ADDENDUM IV

Date of Addendum: April 29, 2022

Project Name: UNCW Randall Library Expansion and Renovation

SCO # 18-19656-02A

SHEET:
EU106

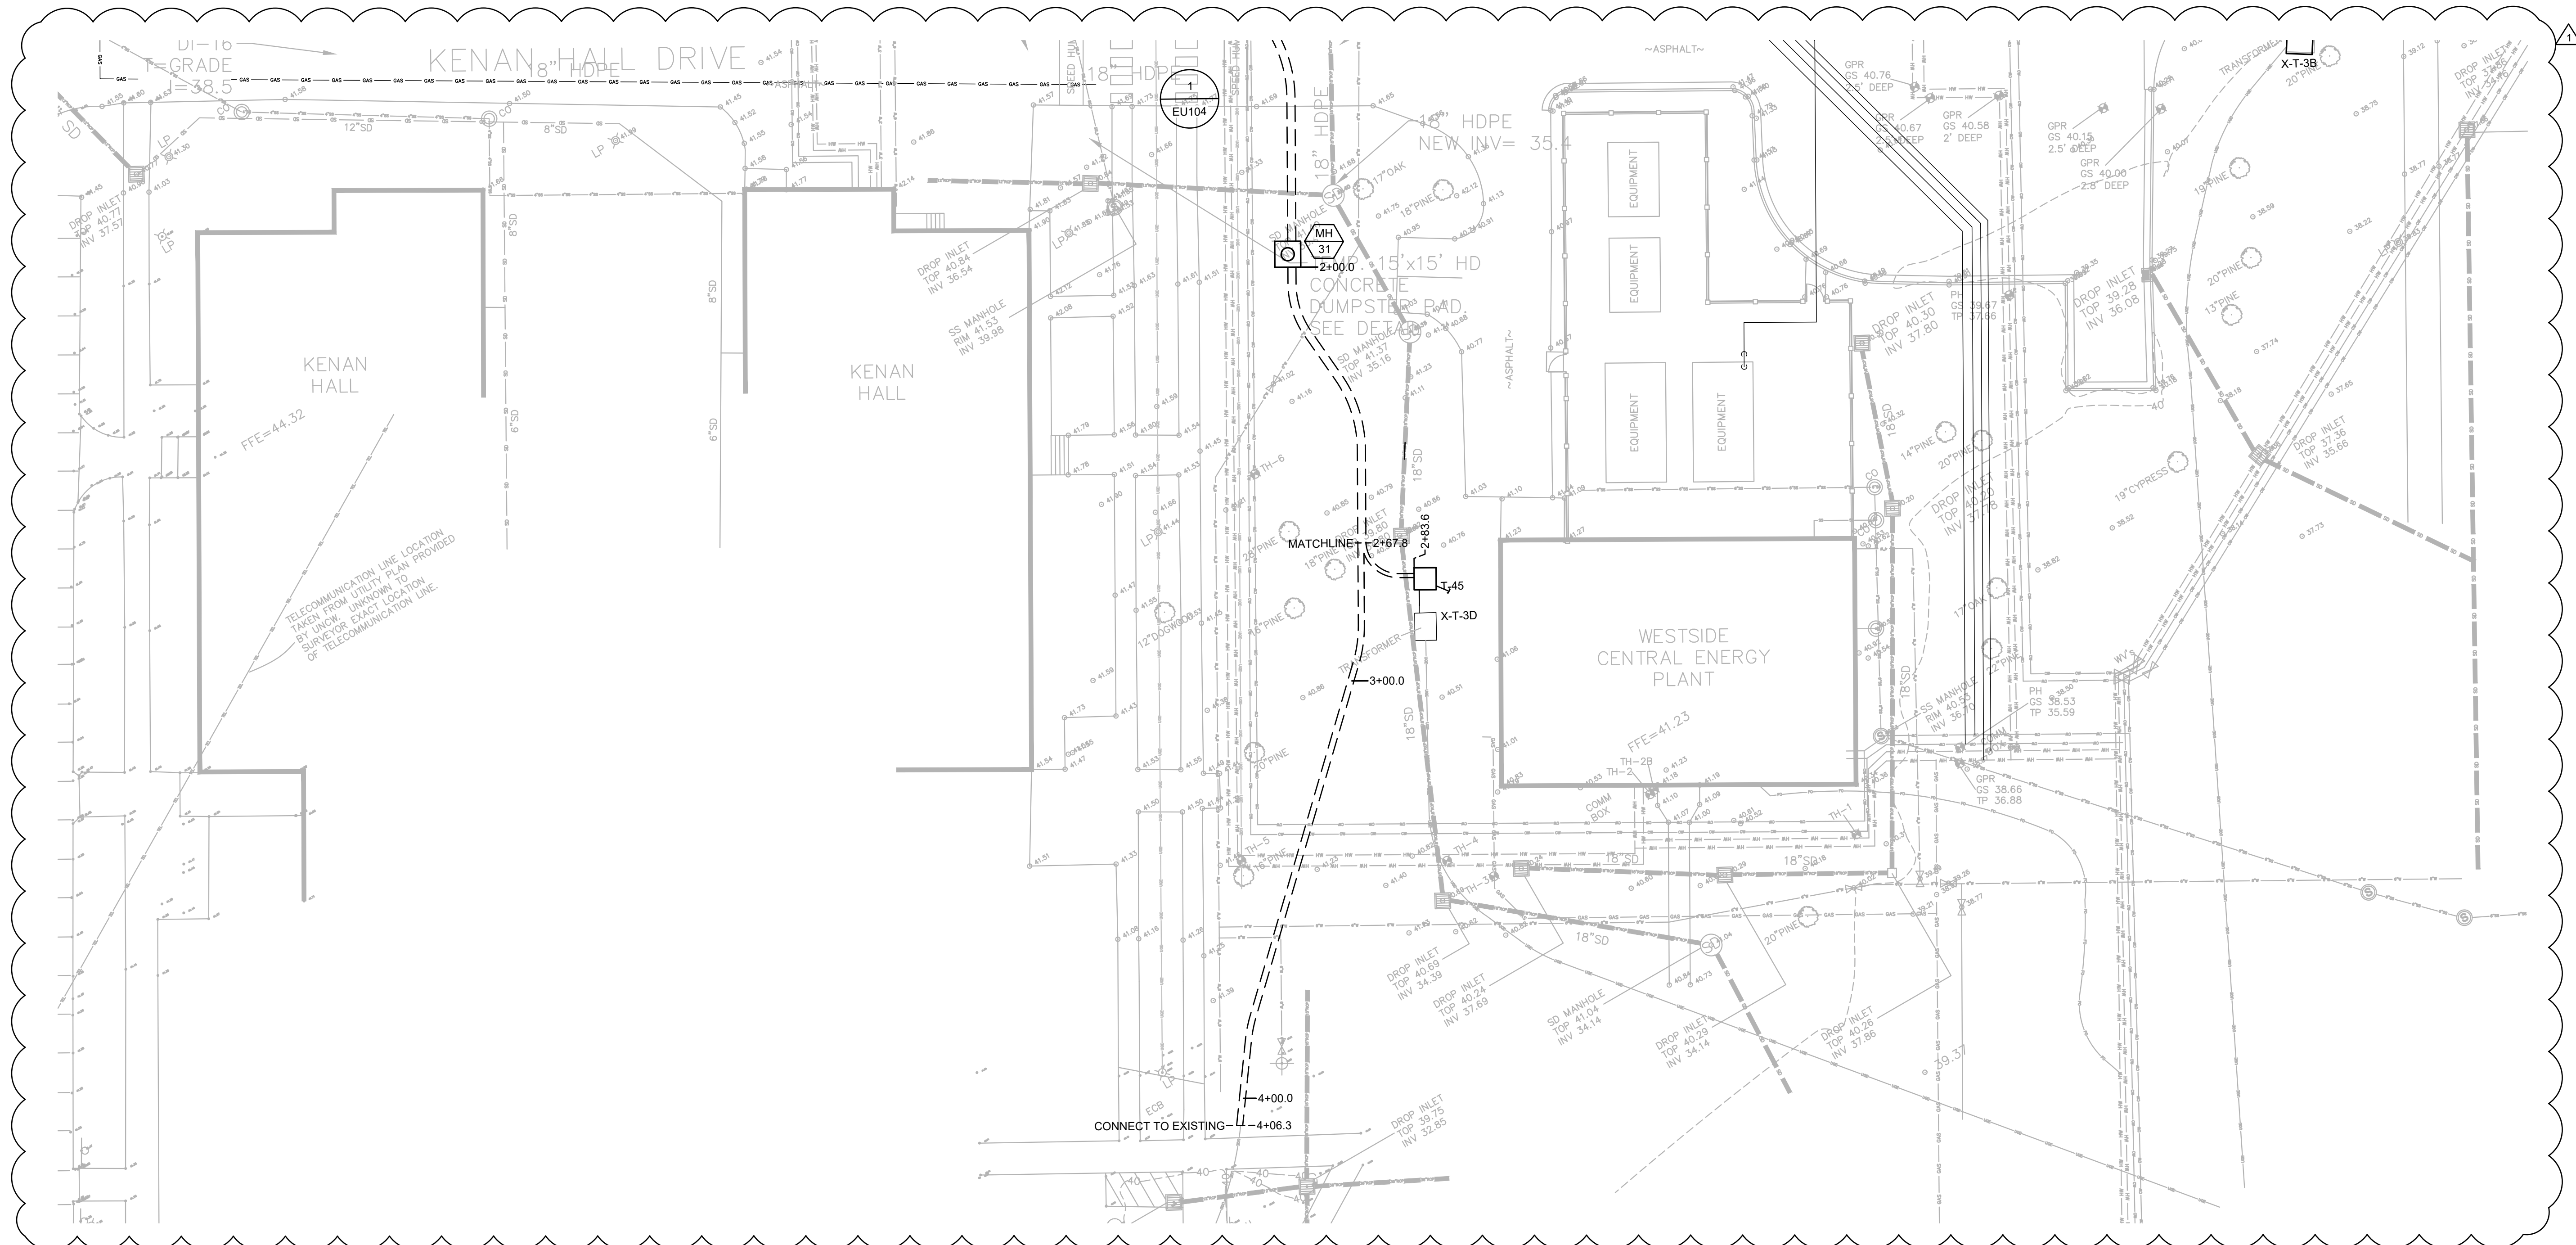
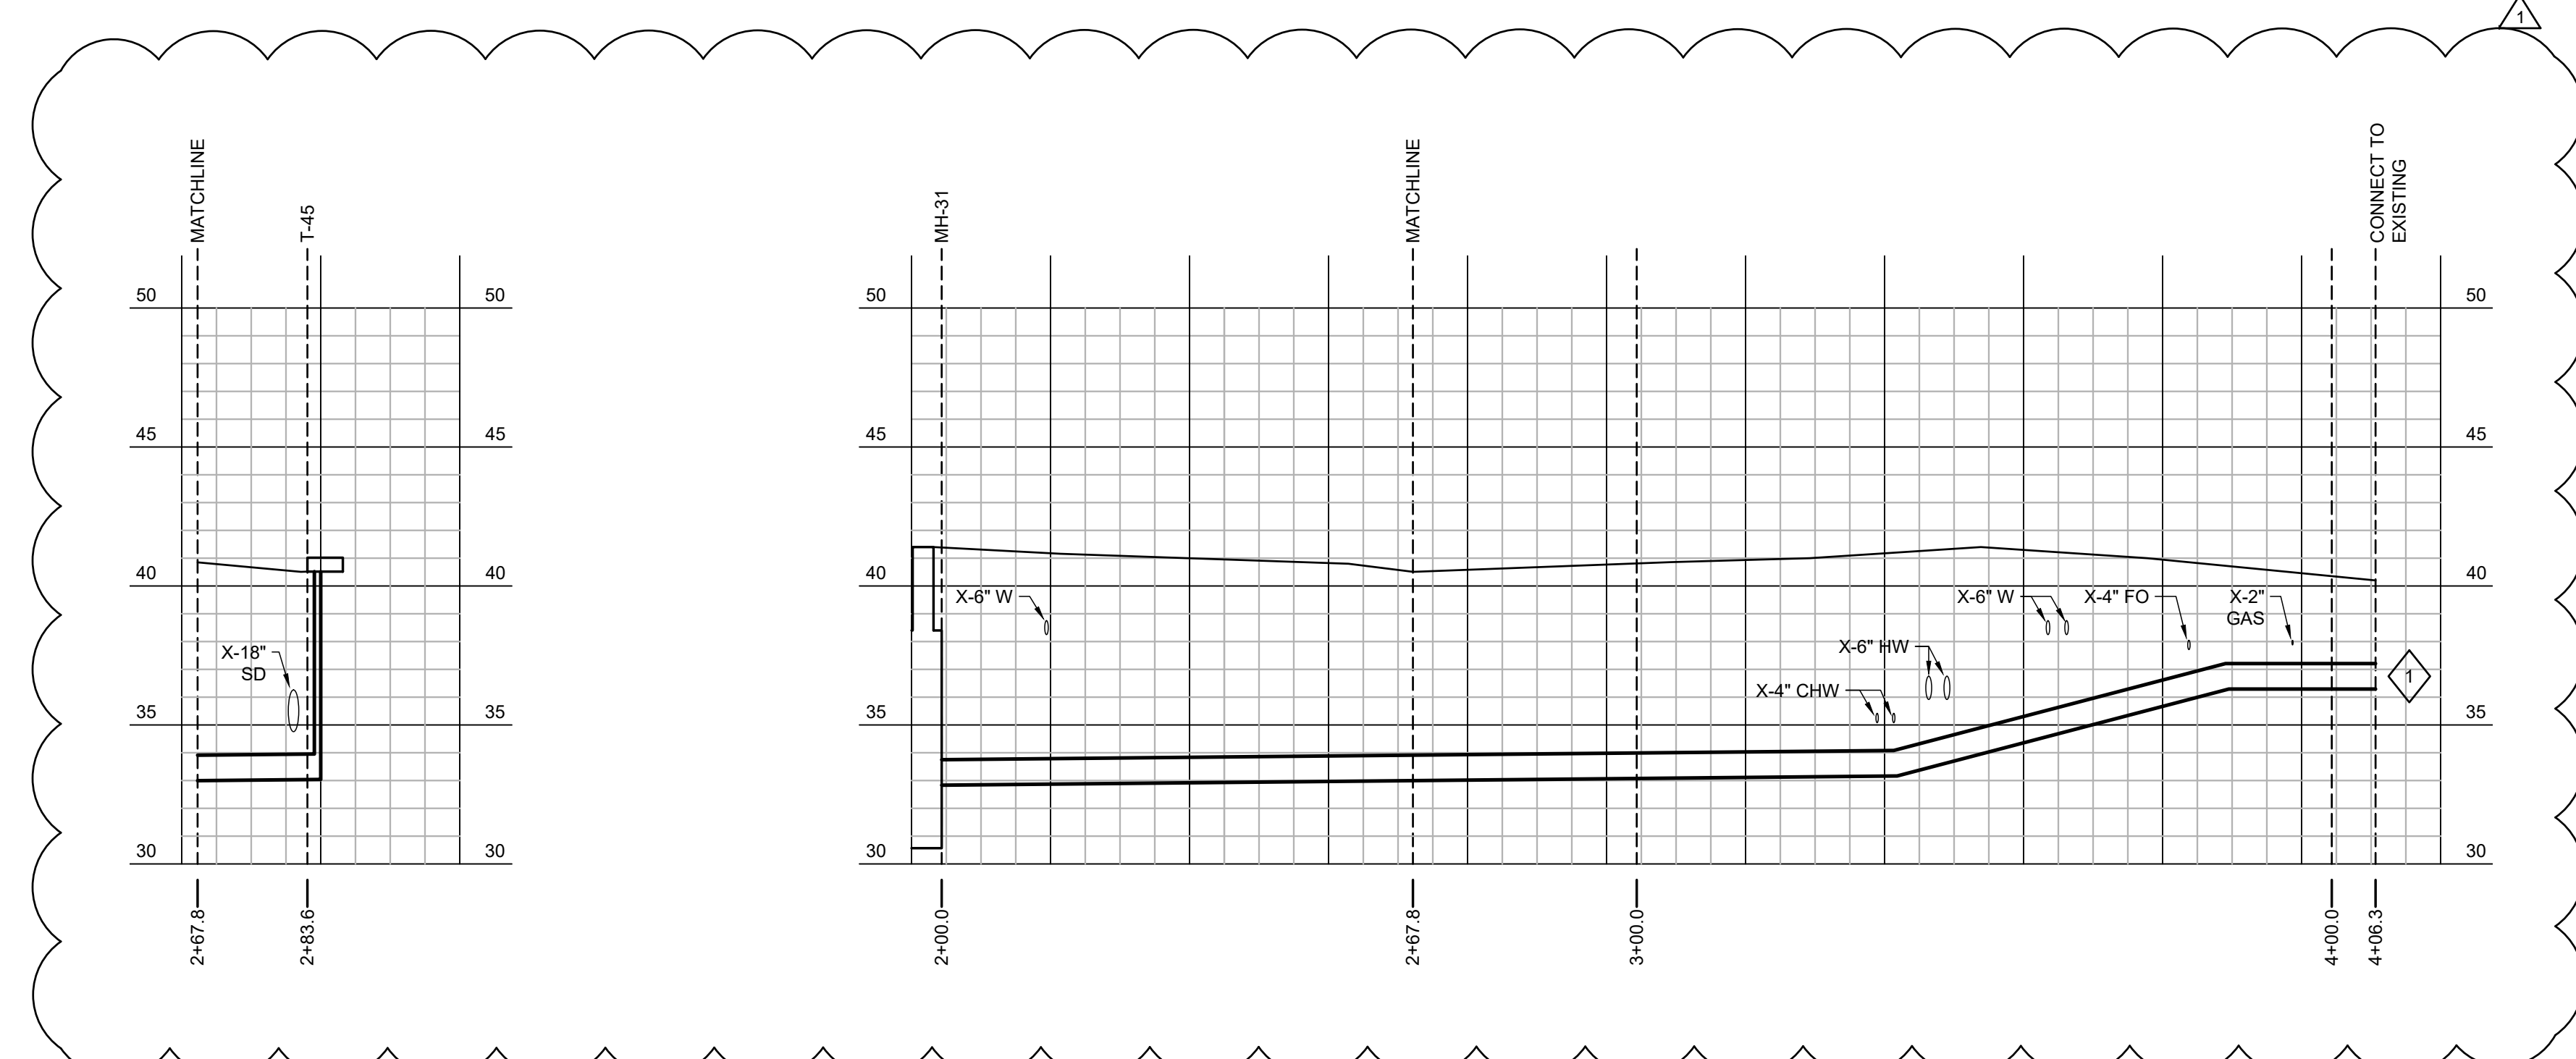
Item IV-11. Sheets EU100, EU102, EU103, EU104, EU105, EU106, EU107 EU108: Replace with revised sheets, included. Updated utility routing per UNCW direction.

HEET: **EU501**

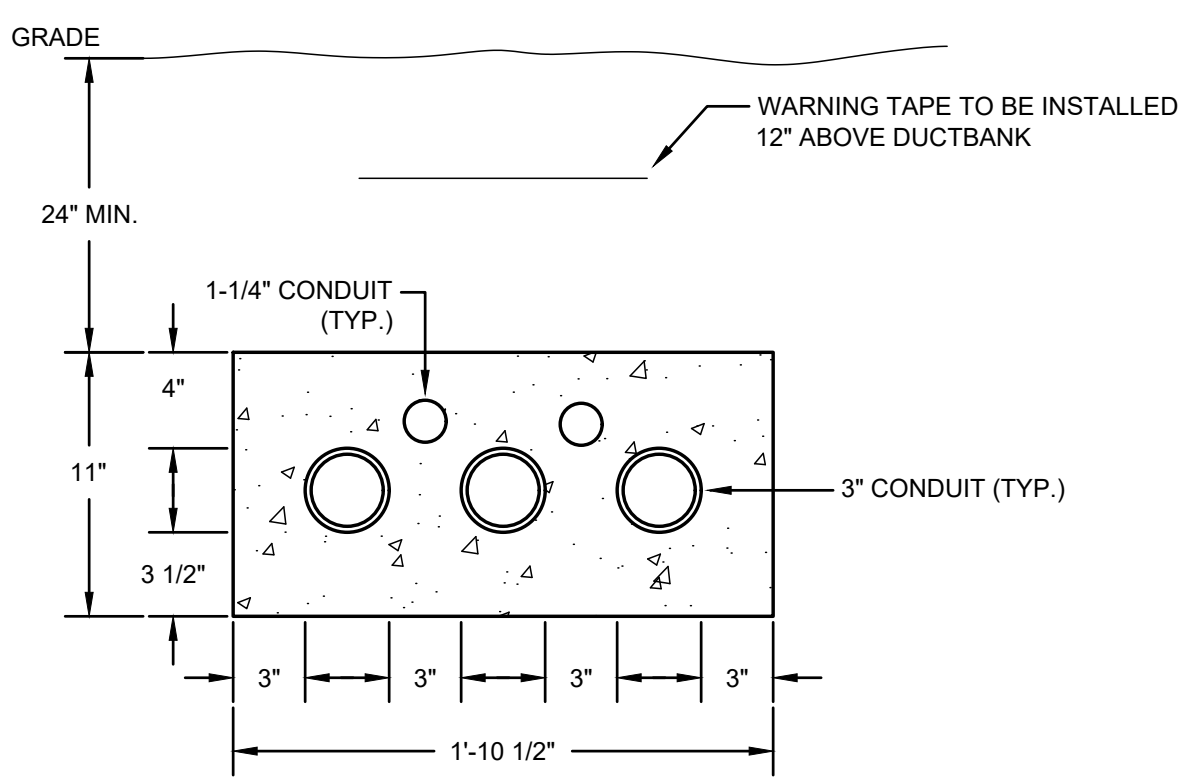
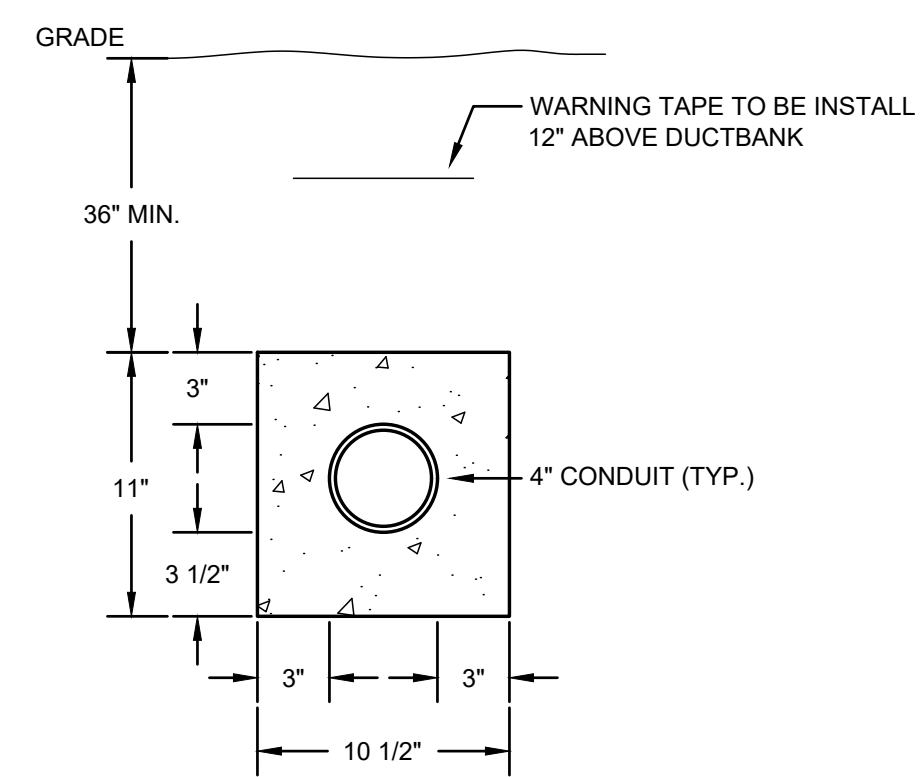
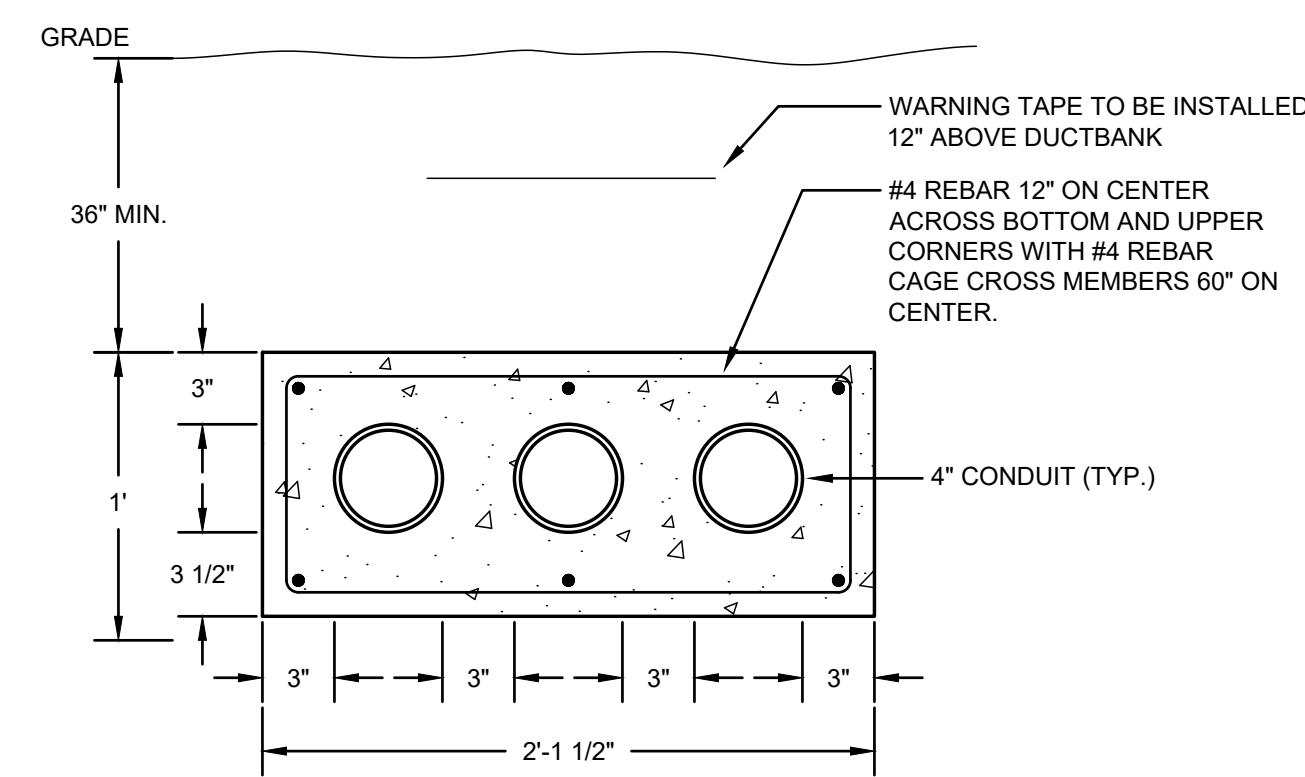
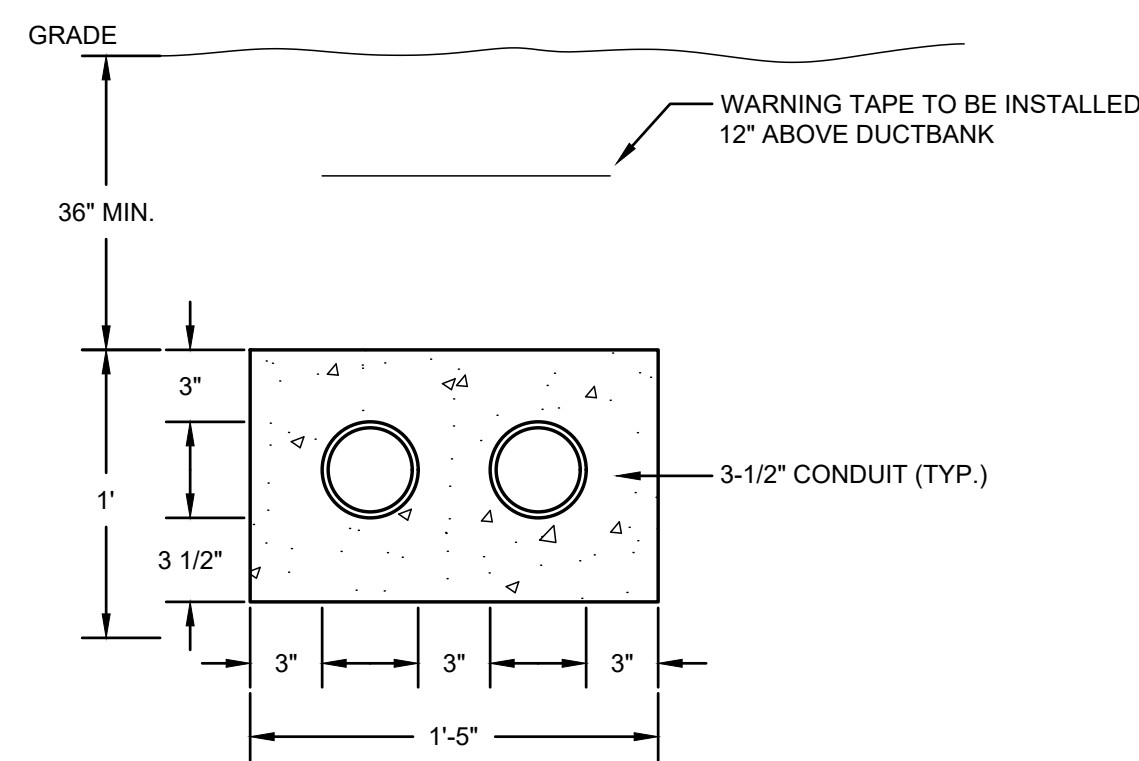
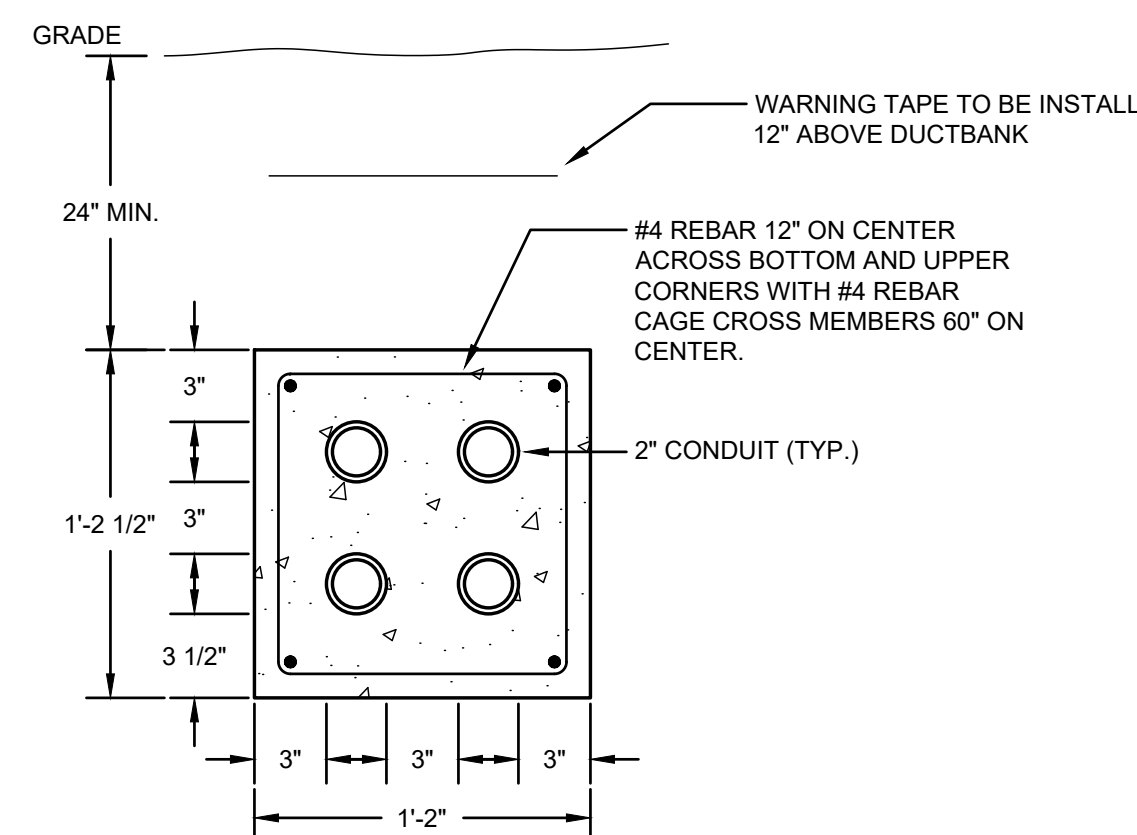
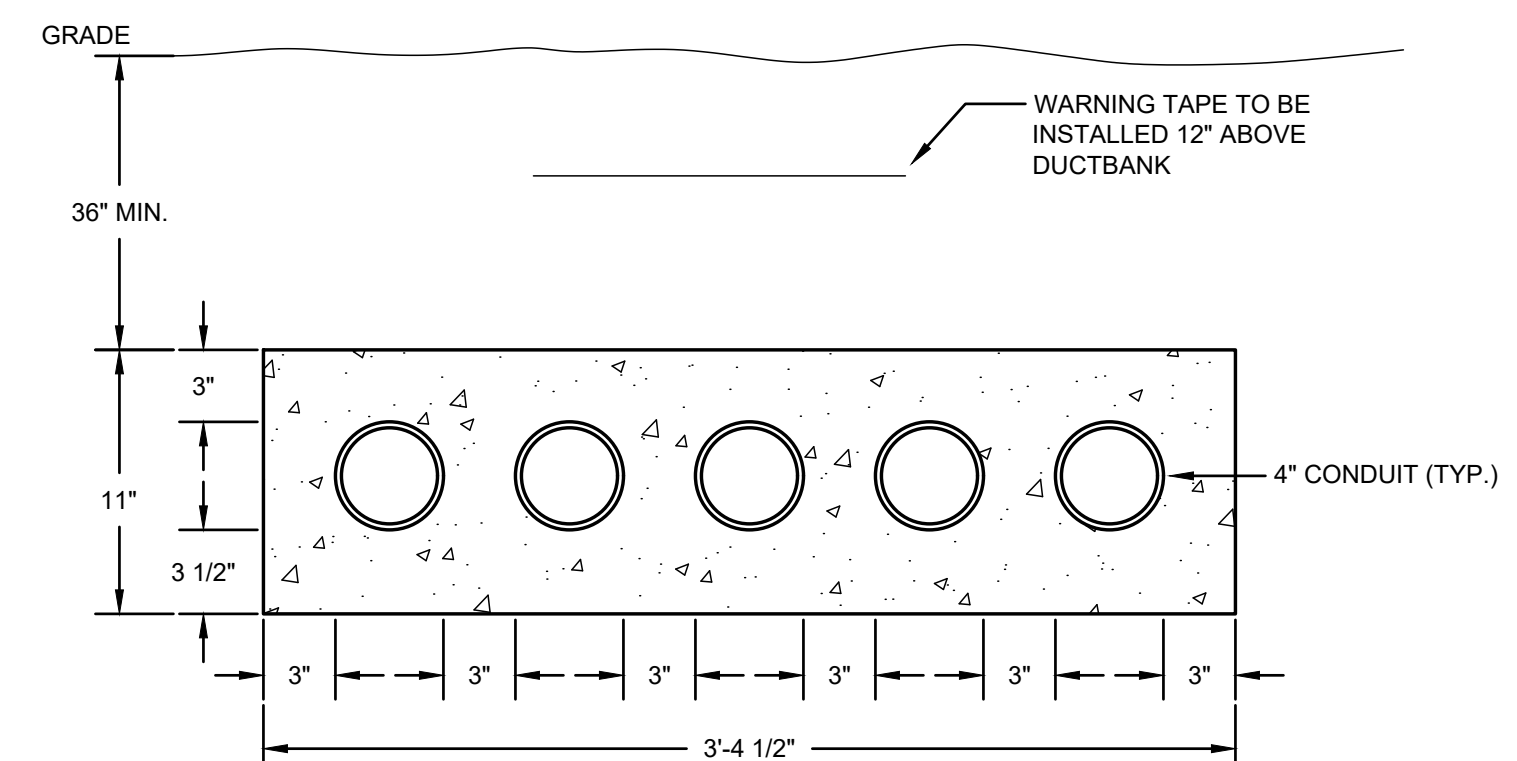
Item IV-13. Sheet EU501: Replace with revised sheet, included. Updated details.
